ADDENDUM NO. 3

Project: American Legion Core Academic Renovation

**AMERICAN LEGION HIGH SCHOOL
CORE ACADEMIC AND CAMPUS RENOVATION
SACRAMENTO CITY UNIFIED SCHOOL DISTRICT
DSA App # 02-116158; DSA File # 34-H7**

ADDENDUM # 3 – REBID
July 25, 2018

SHEET NUMBER
ADD-3R
L-3

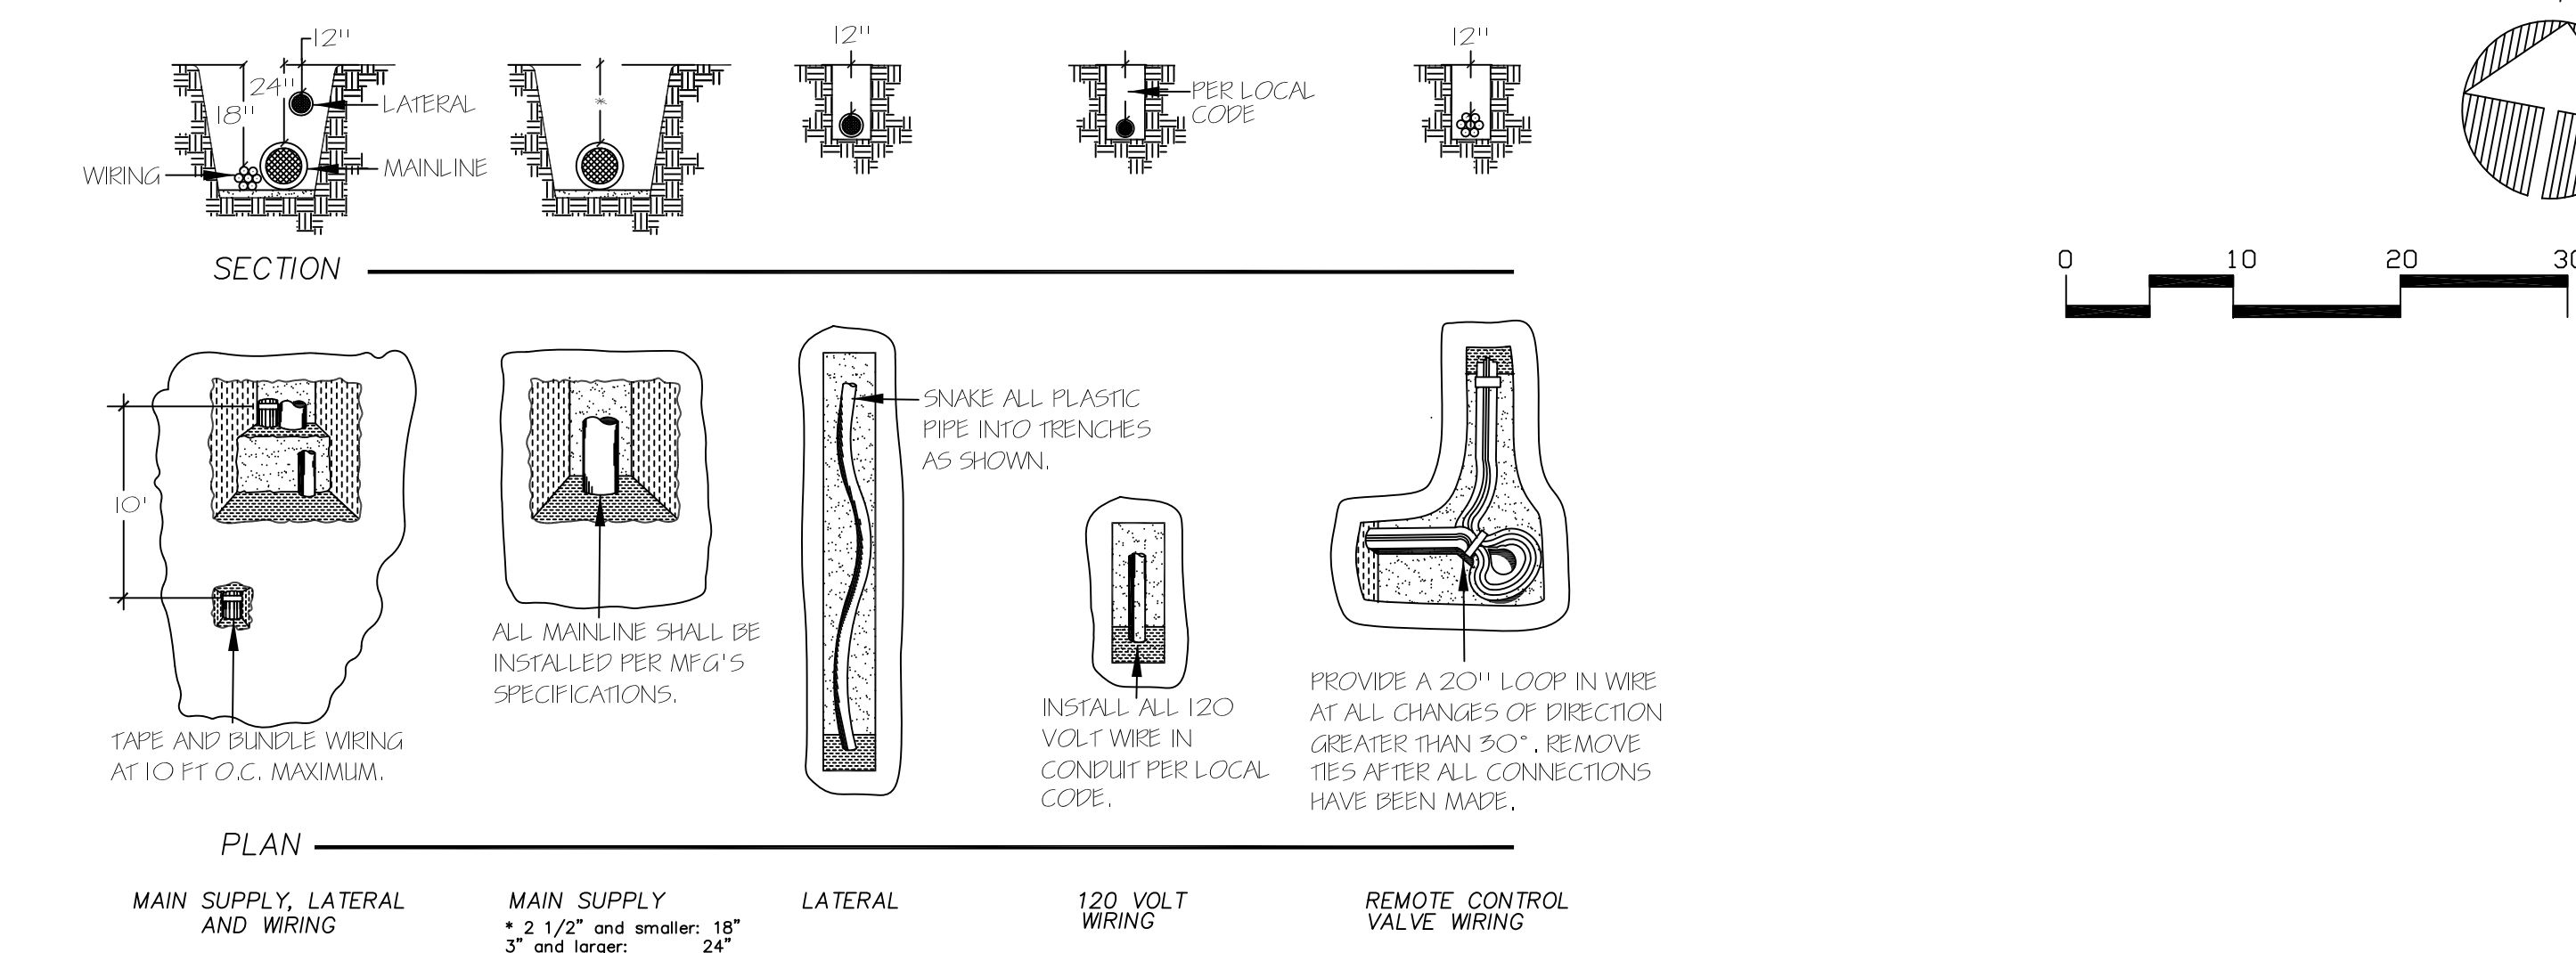
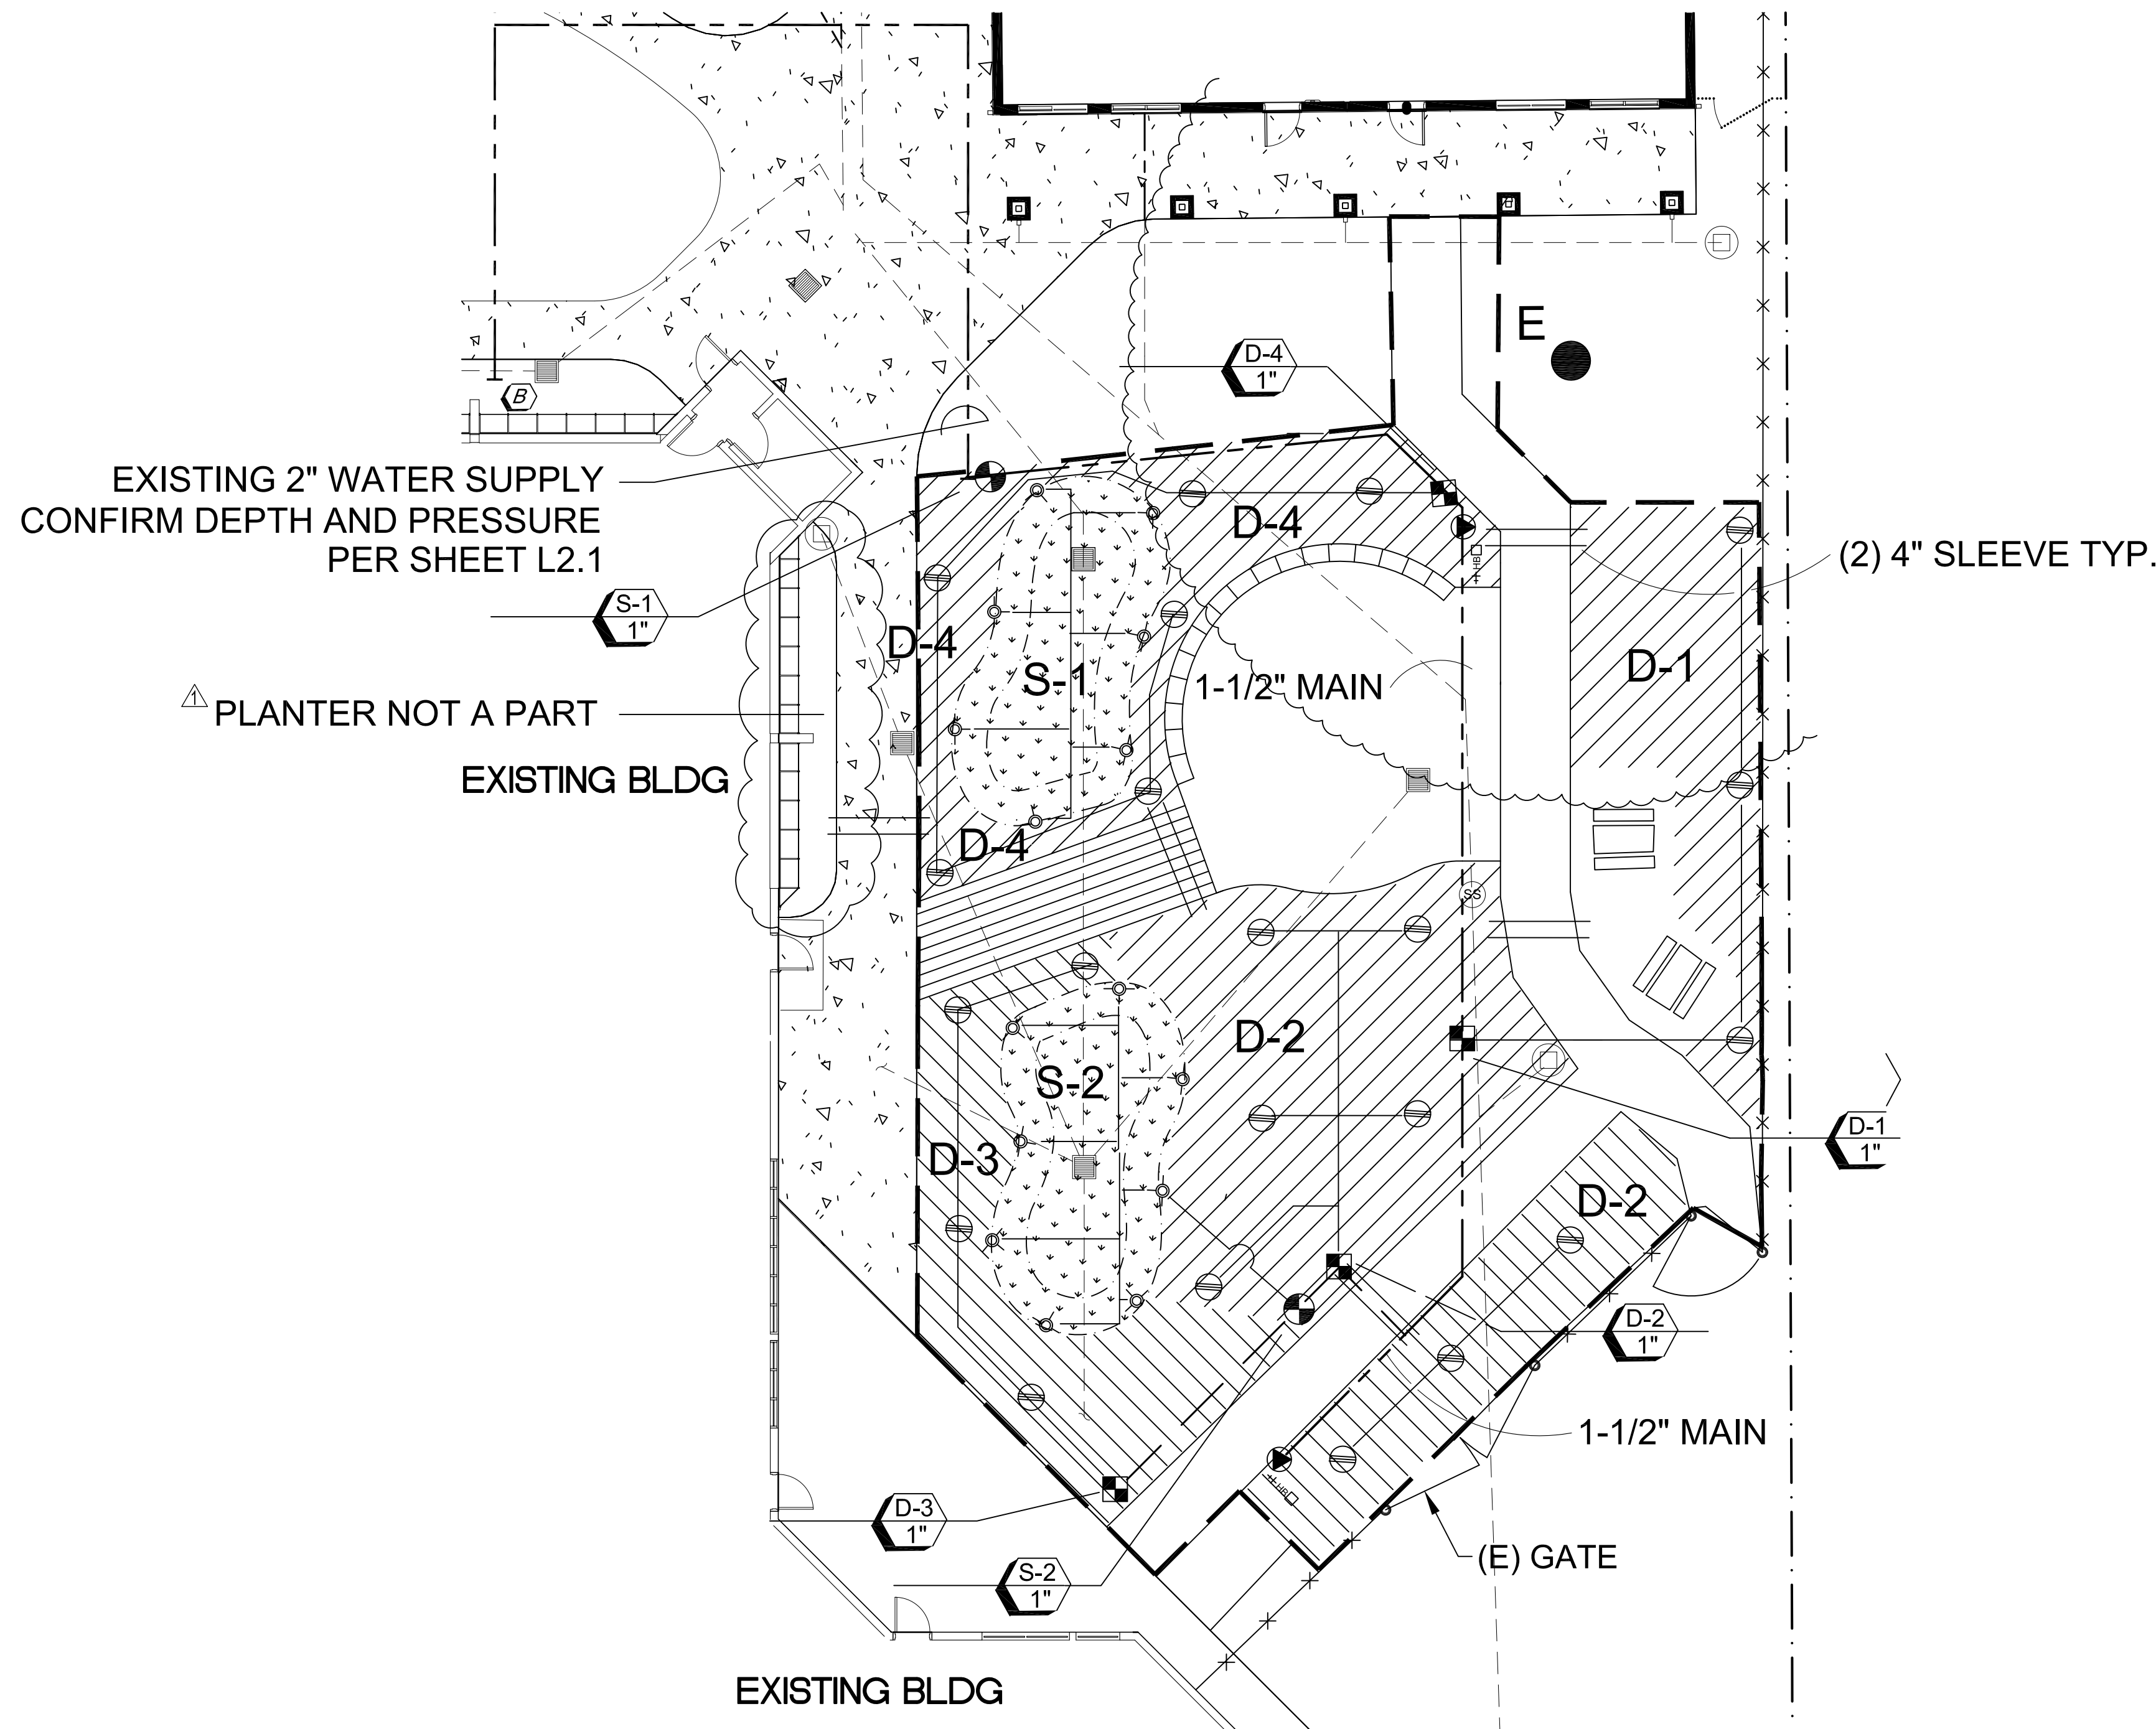
ITEM # 3R.20 Sheet L-3 – Irrigation Plan: Replace with the attached **Sheet ADD-3R L-3 – Irrigation Plan**. Multiple changes have been made on this sheet; major changes have been clouded, all changes are tagged.

SHEET NUMBER
 ADD-3R
 L-4

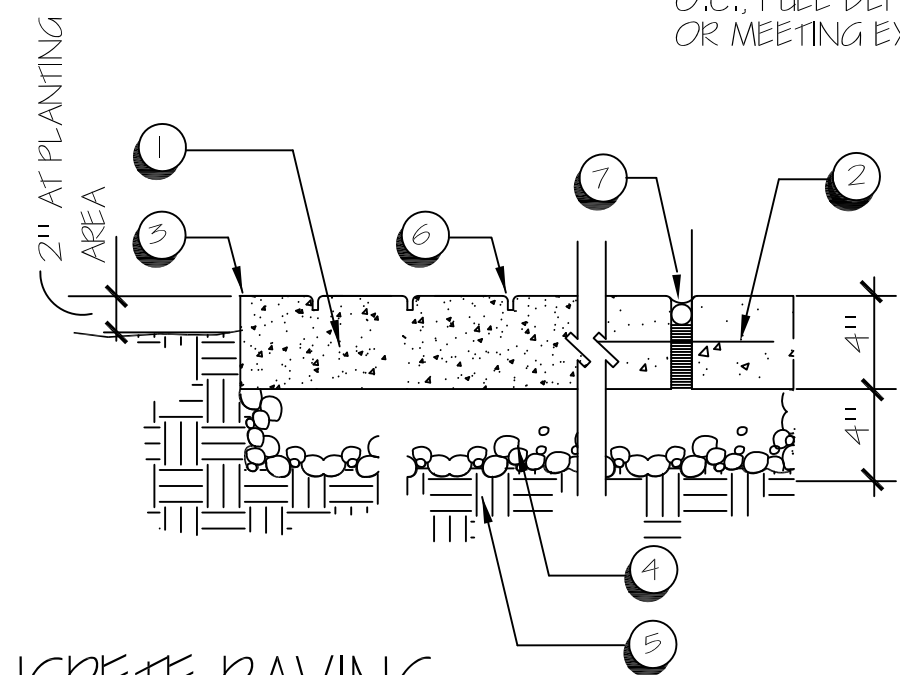
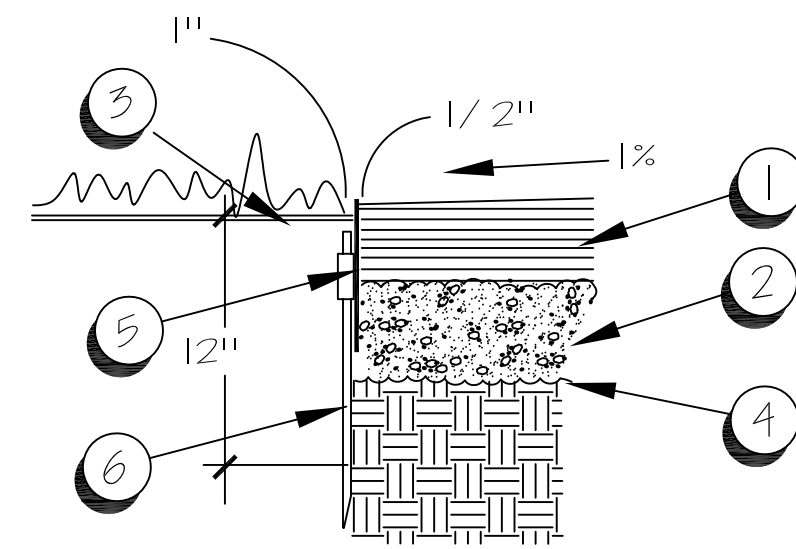
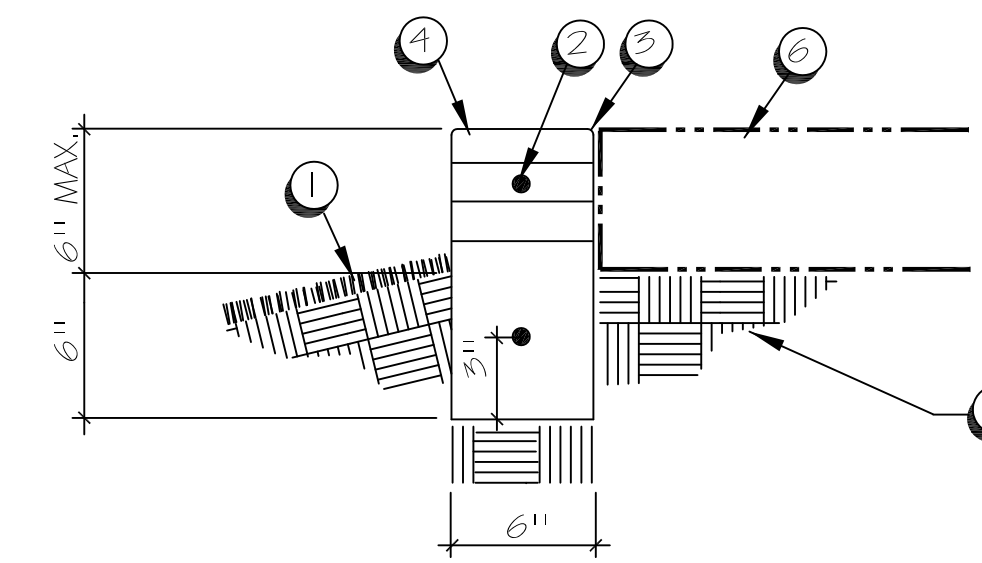
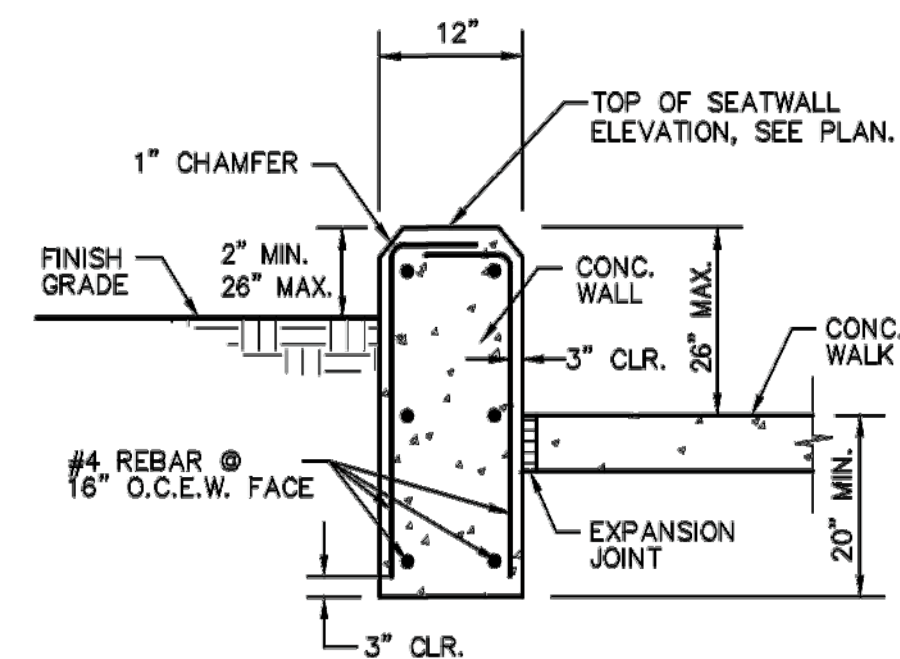
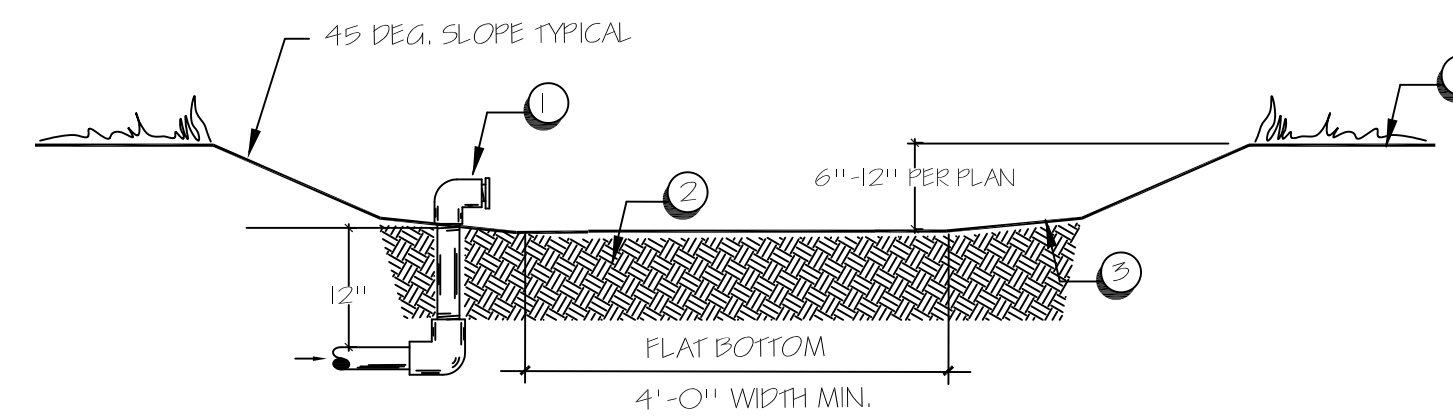
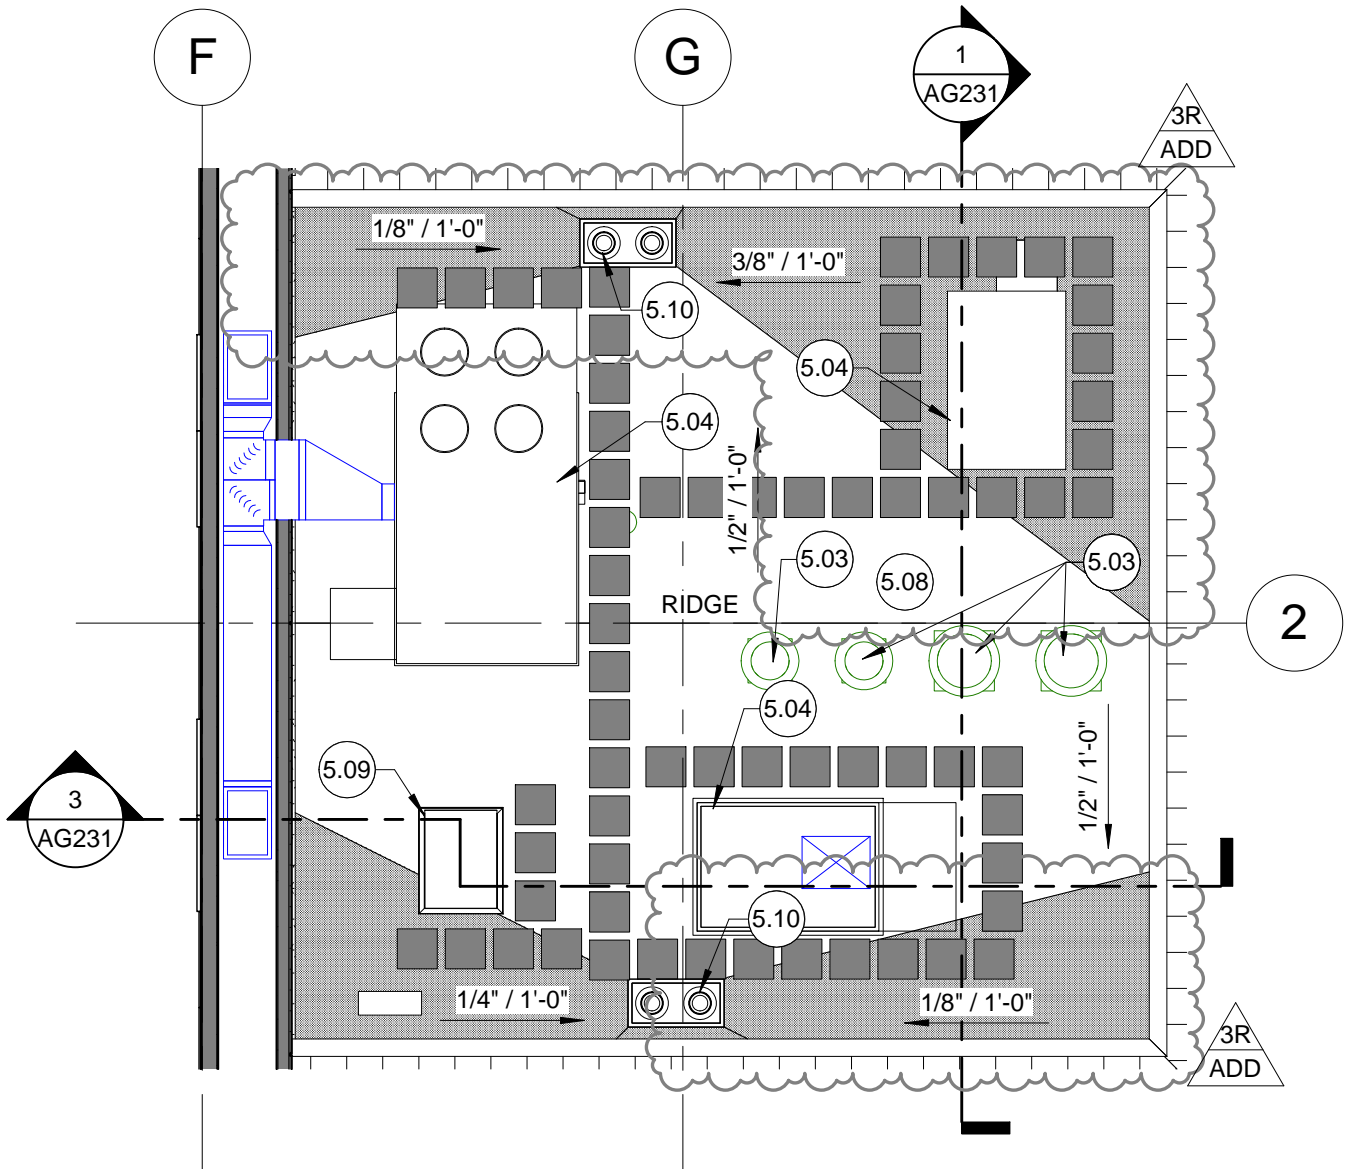
- ITEM # 3R.21** Sheet L-4 – Construction Details: Replace with the attached **Sheet ADD-3R L-4 – Construction Details**. All changes have been clouded.

NE
 CHECKED
 ST
**ADD-3R
 A/AG161**

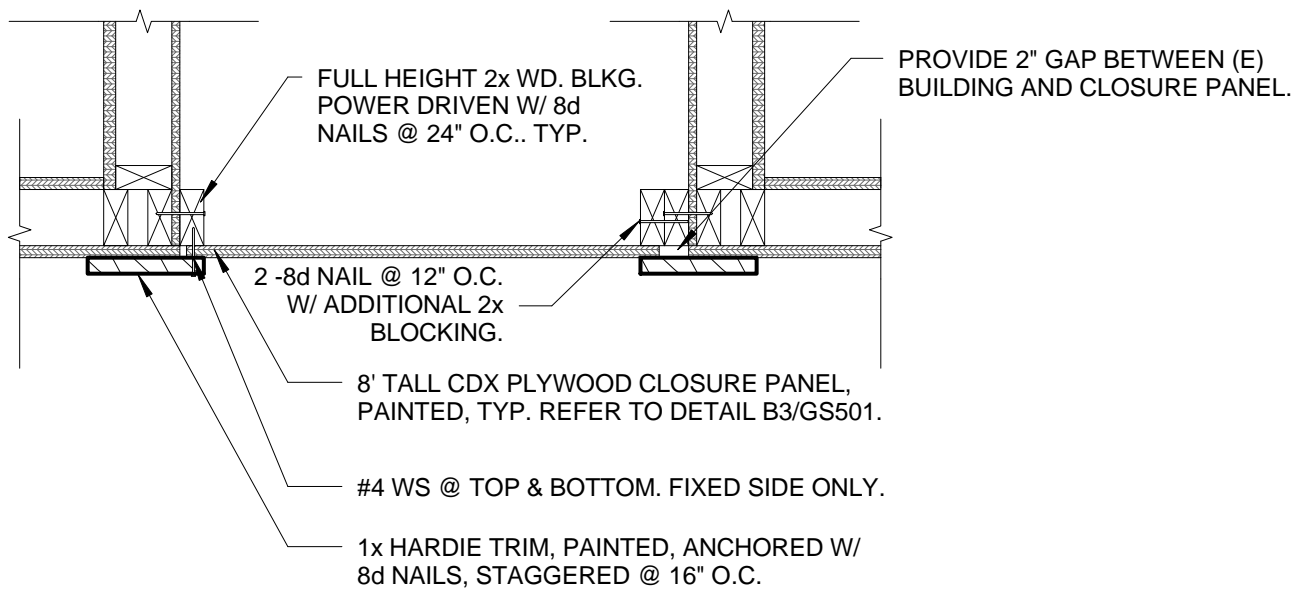
- ITEM # 3R.23** Sheet AG161 – Low Roof Plan: Update this Sheet as shown on the attached **ADD-3R A/AG161**. All changes have been clouded.
- ITEM # 3R.24** Sheet ADD-1R AG291 – Interior Elevations:
